CHANGE ORDER #1

CITY OF PACIFIC
STEWART ROAD PERMITTING & DESIGN PROJECT
BETWEEN VALENTINE AVE SE & BUTTE AVE E

ILLUMINATION & INTERCONNECT PLAN
STEWART RD SE
STA 30+00 TO STA 34+50
KPG PROJECT No. 17168 | SHT 27 OF 56

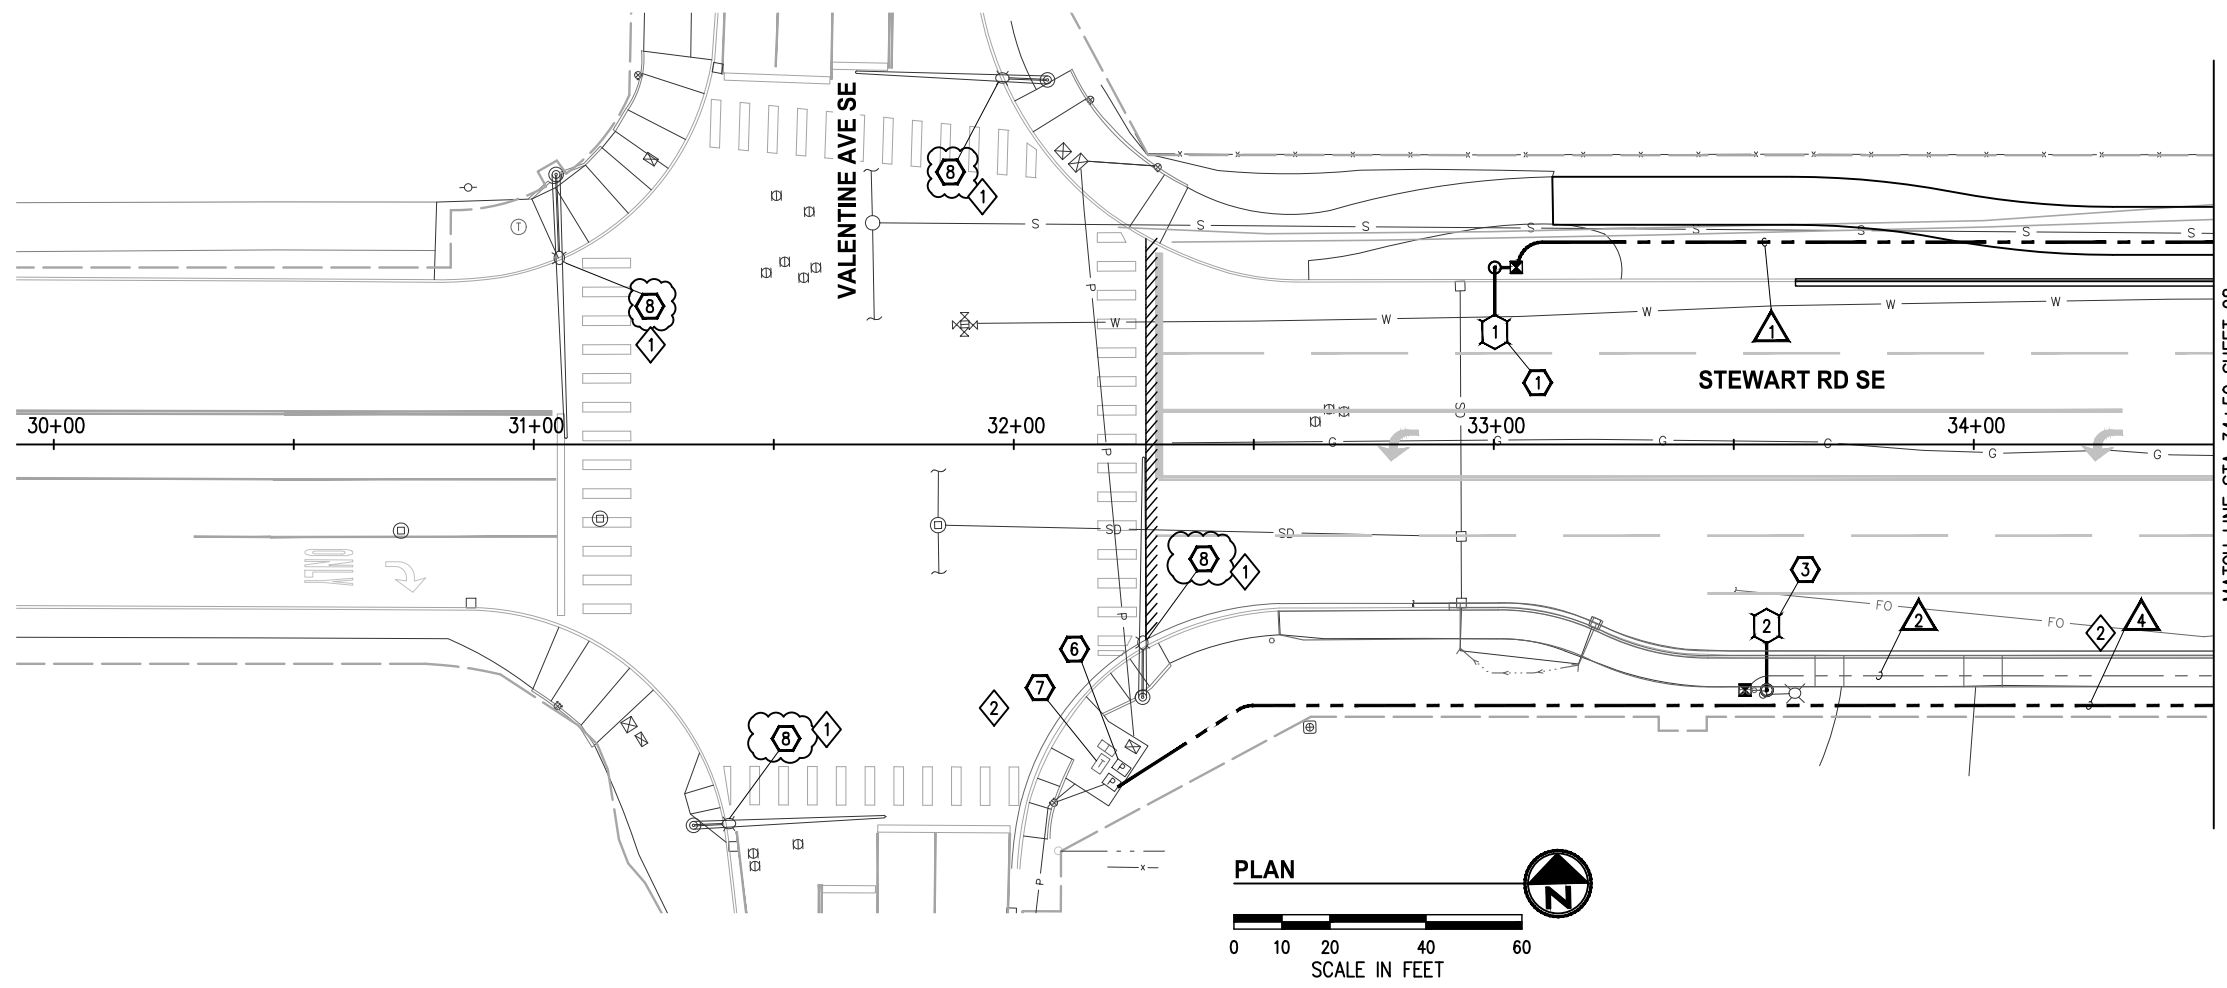
- LOCATION OF EXISTING TRAFFIC SIGNAL CONTROLLER CABINET. CONTRACTOR TO FURNISH AND INSTALL PRE-TERMINATED PATCH CABLE INSIDE EXISTING TRAFFIC SIGNAL CABINET FOR FIBER CONNECTION TO INTERSECTION OF BUTTE AVE AND STEWART RD SW. CONTRACTOR TO TERMINATE RAILROAD WIRING AND INSTALL EQUIPMENT FOR RAILROAD INTERCONNECT INSIDE EXISTING TRAFFIC SIGNAL CONTROLLER CABINET. COORDINATE WORK WITH KING COUNTY TRAFFIC SIGNAL TECHNICIAN. SEE SPECIAL PROVISIONS.

NO.	DATE	BY	APPR.	REVISIONS
1	2/26	TD	JC	CHANGE ORDER 1 - REVISED INTERCONNECT AND SIGNAL WIRING
2	2/8	TD	JC	ADDENDUM 2 - REVISED INTERCONNECT AND SIGNAL WIRING

RACEWAY/ CONDUIT SIZE	CONDUCTORS	COMMENTS
1 2"	BY PSE POLE SERVICES	
2 EX 2"	BY PSE POLE SERVICES	
3 2"	1-14C(#12)	RAILROAD INTERCONNECT
4 2"	1-26(#12), 1-12CT(SMFO)	RAILROAD INTERCONNECT, SIGNAL INTERCONNECT
5 HDPE 1 1/2"	1-26(#12), 1-12CT(SMFO)	RAILROAD INTERCONNECT, SIGNAL INTERCONNECT
6 HDPE 1 1/2"		SPARE

ILLUMINATION & INTERCONNECT PLAN	
STEWART RD SE	
STA 34+50 TO STA 39+00	
KPG PROJECT No. 17168	SHT 28 OF 56

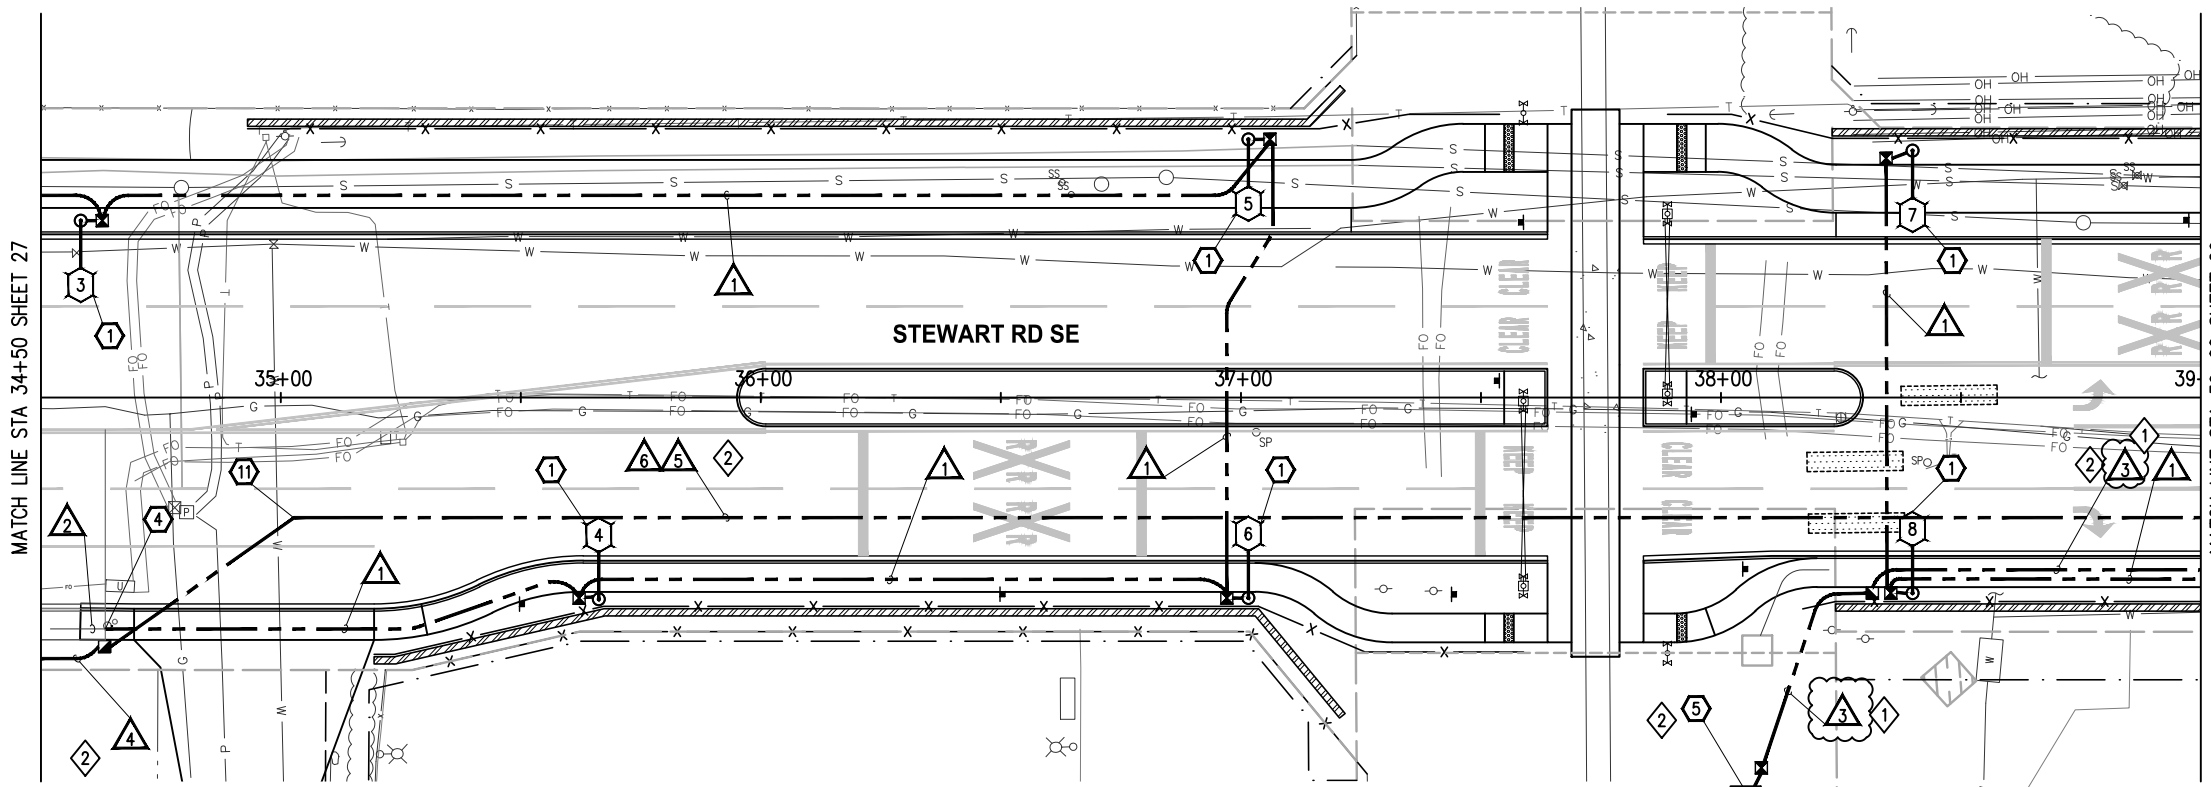
- ④ LOCATE EXISTING EMPTY CONDUIT AND COUPLE TO NEW CONDUIT TO FORM CONTINUOUS RACEWAY PER WIRE NOTES, THIS SHEET.
- ⑤ LOCATION OF UNION PACIFIC RAILROAD (UPRR) SIGNAL HOUSE. CONDUIT AND WIRING FOR RAILROAD PREEMPTION SHALL BE INSTALLED BY CONTRACTOR UP TO JUNCTION BOX LOCATED NEXT TO UPRR SIGNAL HOUSE AS SHOWN ON PLANS AND PER WIRE NOTES, THIS SHEET. FINAL CONDUIT AND WIRING CONNECTION TO UPRR SIGNAL HOUSE SHALL BE PERFORMED BY UPRR. CONTRACTOR SHALL COORDINATE WORK WITH THE RAILROAD REPRESENTATIVE. SEE SPECIAL PROVISIONS.

- ⑩ LOCATION OF EXISTING CONDUIT CASING. CONTRACTOR SHALL EXCAVATE TO EXPOSE EXISTING CASING AND FURNISH AND INSTALL HDPE CONDUIT THROUGH CASING TOWARD INTERSECTION OF BUTTE AND STEWART RD. HDPE CONDUIT SIZE PER WIRE NOTES, THIS SHEET. HDPE CONDUIT SHALL TERMINATE AT JUNCTION BOX AS CALLED OUT ON THIS SHEET. FOR OTHER TERMINATION POINT OF HDPE CONDUIT, SEE SIGNAL SHEETS. COMPLETE WIRING PER WIRE NOTES, THIS SHEET. SEE SPECIAL PROVISIONS.

NO.	DATE	BY	APPR.	REVISIONS
①	2/26	TD	JC	CHANGE ORDER 1 - REVISED INTERCONNECT AND SIGNAL WIRING
②	2/8	TD	JC	ADDENDUM 2 - REVISED INTERCONNECT AND SIGNAL WIRING

RACEWAY/CONDUIT SIZE	CONDUCTORS	COMMENTS
1 2"	BY PSE POLE SERVICES	
2 EX 2"	BY PSE POLE SERVICES	
3 2"	1-14C(#12)	RAILROAD INTERCONNECT
4 2"	1-26(#12), 1-12CT(SMFO)	RAILROAD INTERCONNECT, SIGNAL INTERCONNECT
5 HDPE 1 1/2"	1-26(#12), 1-12CT(SMFO)	RAILROAD INTERCONNECT, SIGNAL INTERCONNECT
6 HDPE 1 1/2"		SPARE

ILLUMINATION & INTERCONNECT PLAN
STEWART RD SE
STA 39+00 TO STA 43+20

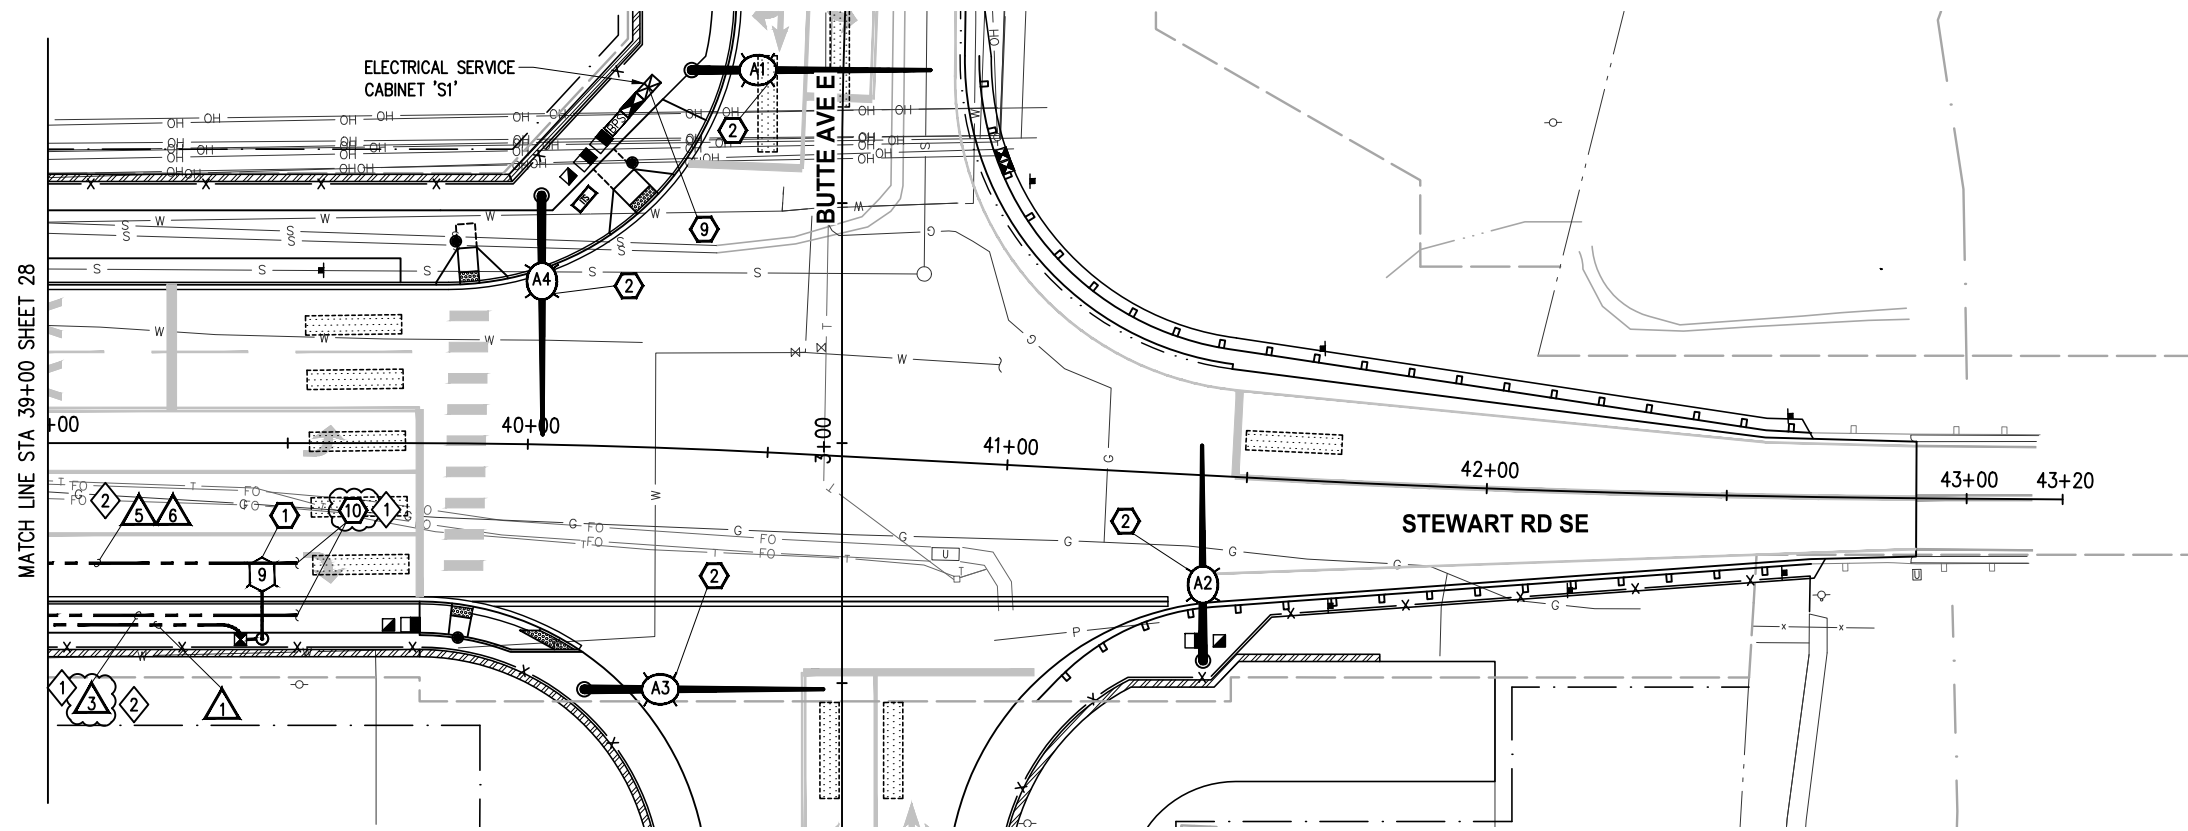
NO.	DATE	BY	APPR.	REVISIONS
①	2/26	TD	JC	CHANGE ORDER 1 - REVISED INTERCONNECT AND SIGNAL WIRING
②	2/8	TD	JC	ADDENDUM 2 - REVISED INTERCONNECT AND SIGNAL WIRING

NO.	RACEWAY/CONDUIT SIZE	CONDUCTORS	COMMENTS
1	2"	BY PSE POLE SERVICES	
2	EX 2"	BY PSE POLE SERVICES	
3	2"	1-14C(#12)	RAILROAD INTERCONNECT
4	2"	1-26(#12), 1-12CT(SMFO)	RAILROAD INTERCONNECT, SIGNAL INTERCONNECT
5	HDPE 1 1/2"	1-26(#12), 1-12CT(SMFO)	RAILROAD INTERCONNECT, SIGNAL INTERCONNECT
6	HDPE 1 1/2"		SPARE

SIGNALIZATION PLAN
STEWART RD SE & BUTTE AVE E
KPG PROJECT No. 17168 | SHT 31 OF 56

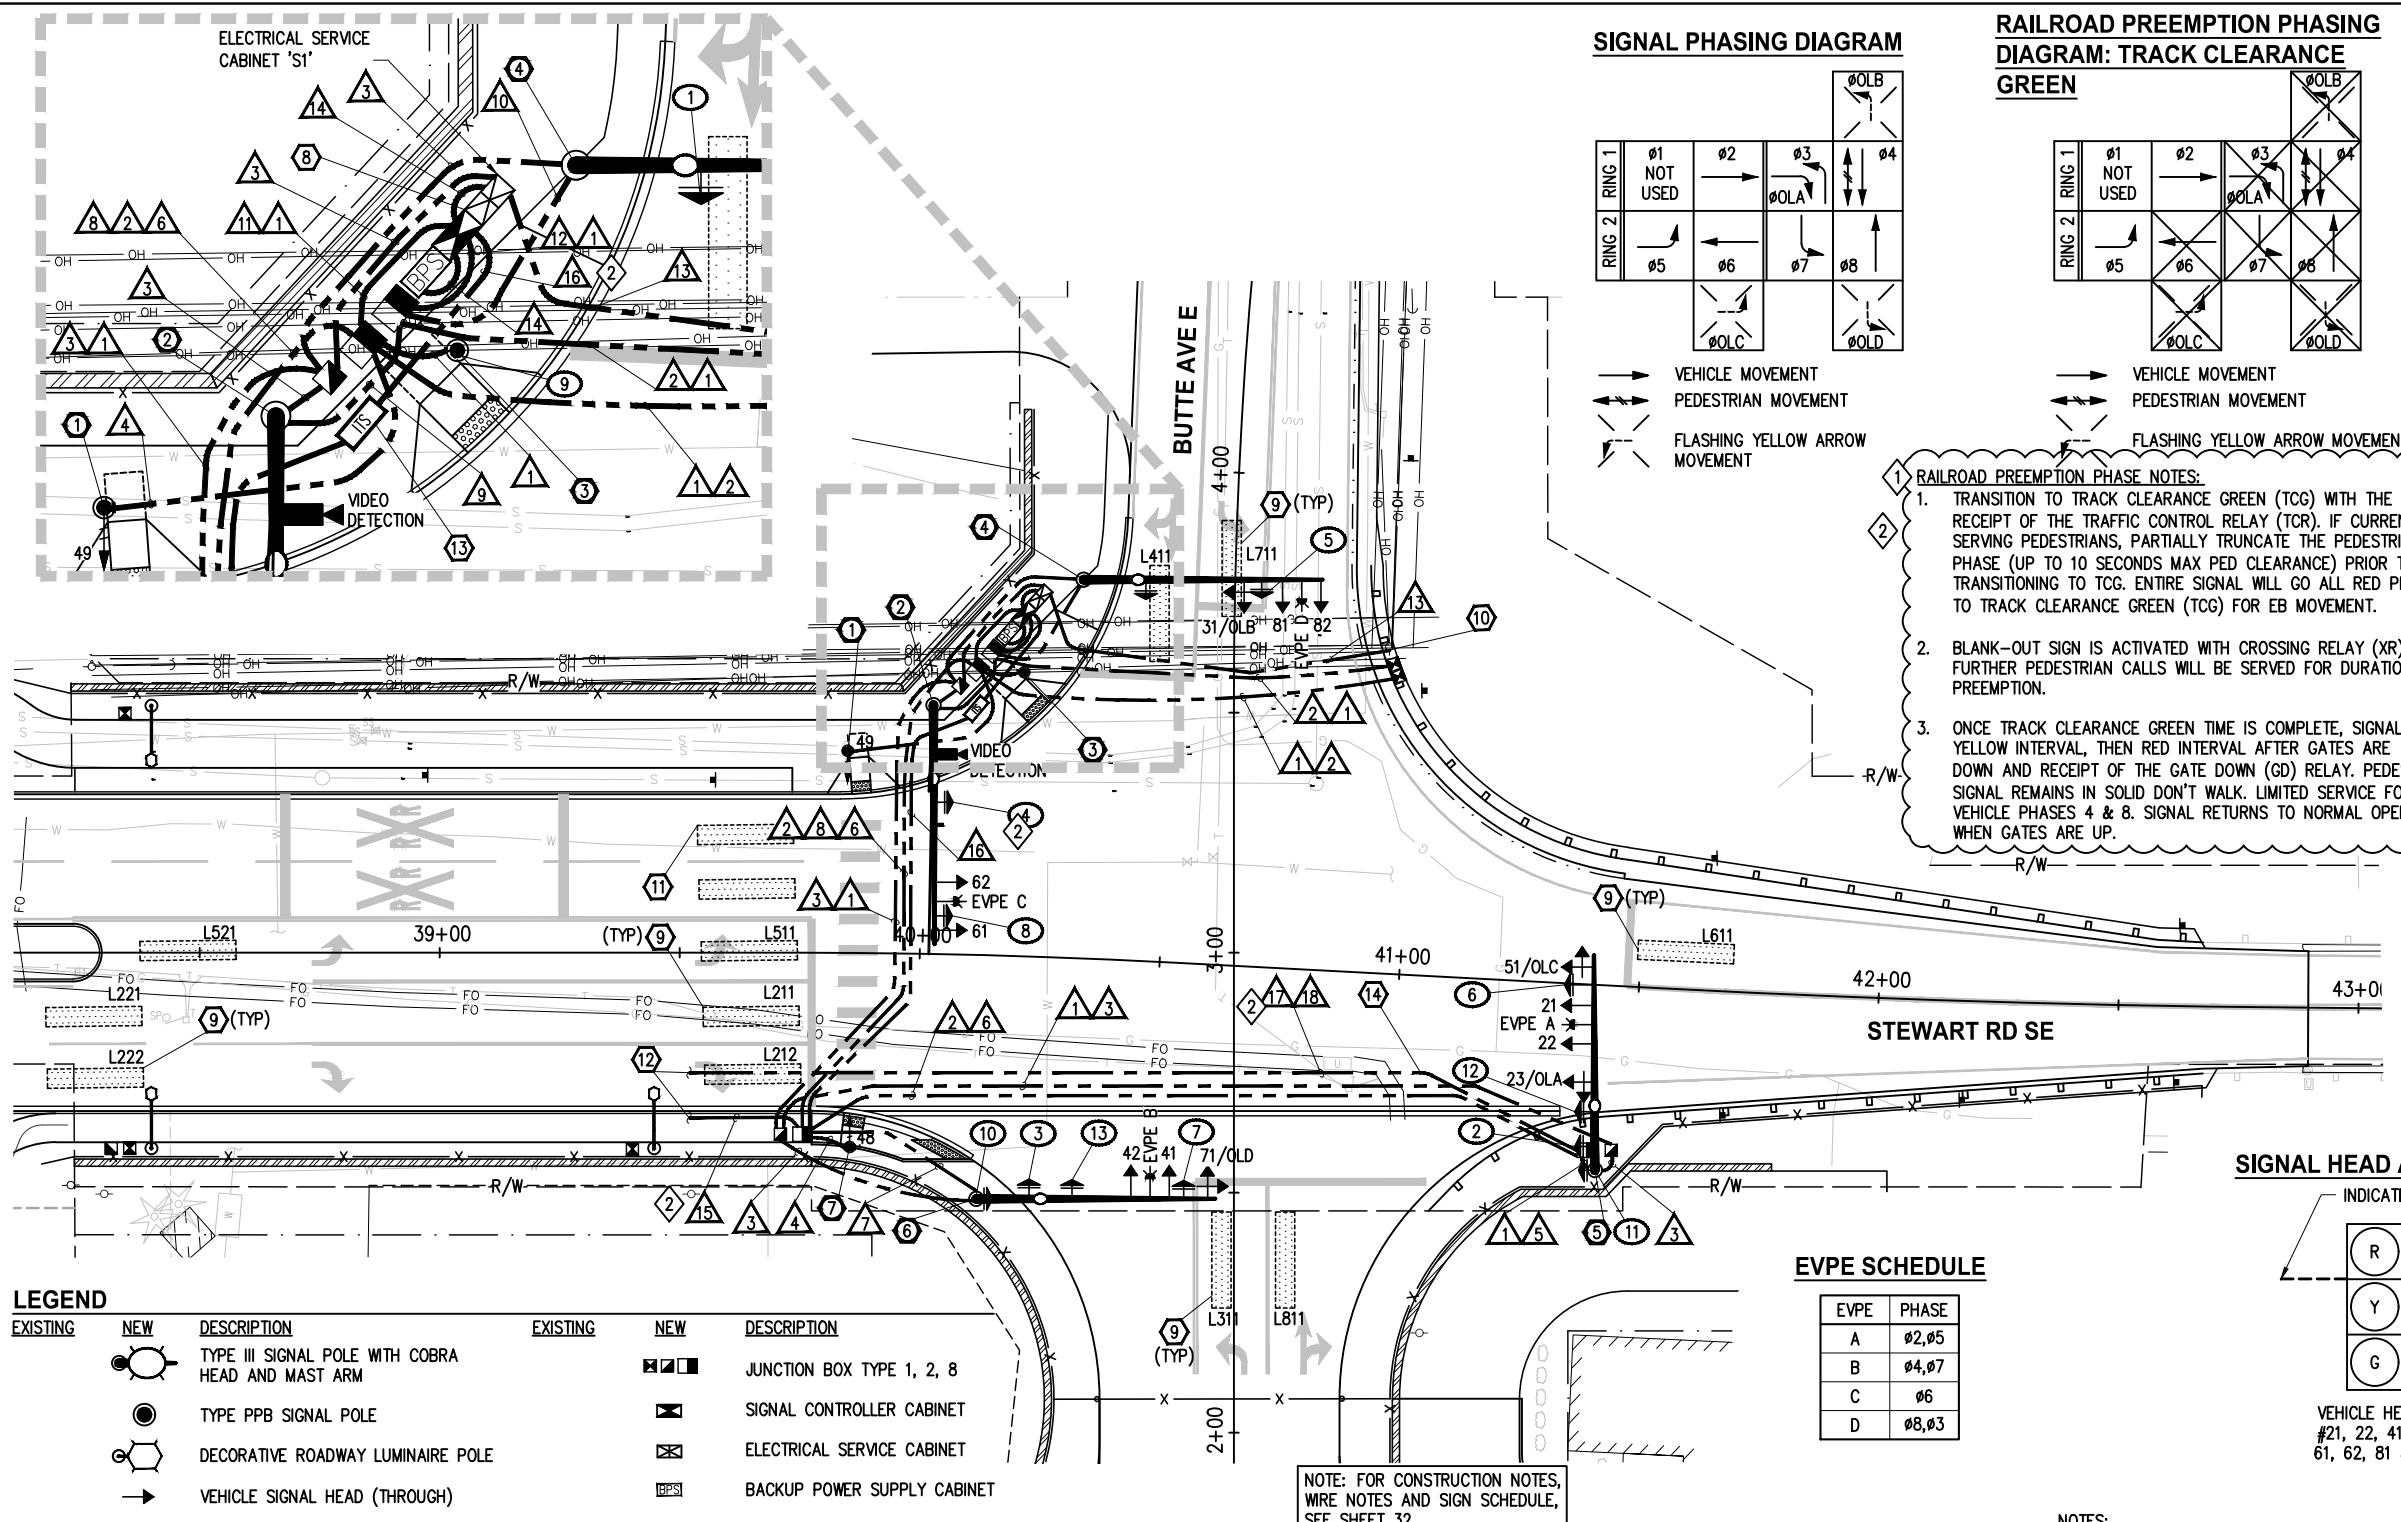
NO.	DATE	BY	APPR.	REVISIONS
1	2/26	TD	JC	CHANGE ORDER 1 - REVISED INTERCONNECT AND SIGNAL WIRING
2	2/8	TD	JC	ADDENDUM 2 - REVISED INTERCONNECT AND SIGNAL WIRING

13. FURNISH AND INSTALL SMALL CABLE VAULT PER WSDOT STD PLAN J-90.21 AND SPLICE FIBER OPTIC PATCH CABLE FROM INTERSECTION OF VALENTINE AVE SE AND STEWART RD SE INSIDE SMALL CABLE VAULT. COMPLETE WIRING TO NEW TRAFFIC SIGNAL CONTROLLER CABINET PER WIRE NOTES, THIS SHEET.

14. LOCATION OF EXISTING CONDUIT CASING. CONTRACTOR SHALL EXCAVATE TO EXPOSE END OF EXISTING CASING AND FURNISH AND INSTALL HDPE CONDUIT THROUGH CASING AND INTO JUNCTION BOX AS SHOWN ON THE PLANS. ONCE HDPE CONDUIT IS INSTALLED CONTRACTOR TO SEAL END OF CASING. HDPE CONDUIT SIZE AND WIRE INSTALLATION SHALL BE PER WIRE NOTES, THIS SHEET. SEE SPECIAL PROVISIONS.

NO.	RACEWAY / CONDUIT SIZE	CONDUIT HEAD										COMMENTS			
		5C (VEHICLE HEAD)	5C (PEDESTRIAN HEAD)	5C (BLANK OUT SIGN)	2CS (PPB)	3CS (E/PE INDICATOR)	CAT6 (VIDEO DETECTOR)	#6 (ILLUMINATION)	#6 (CONTROLLER POWER)	#3/0 (SERVICE)	1-14C (RAIL ROAD PE)		1-12C (SMFD)		
1	2"														SPARE
2	3"														SPARE
3	2"														
4	2"														
5	3"	4	1			1	1								
6	3"	4	1			1	1								
7	3"	3	1	1		1	1								
8	3"	3	2	1	1	1	1								
9	3"	1	1			1	1	1							
10	3"	3				1	1								
11	4"	7	4	1	2	2	2								
12	3"	4	2		1	2	2	1							
13	3"														
14	2"														
15	2"														
16	2"														
17	HDPE 1 1/2"														
18	HDPE 1 1/2"														SPARE
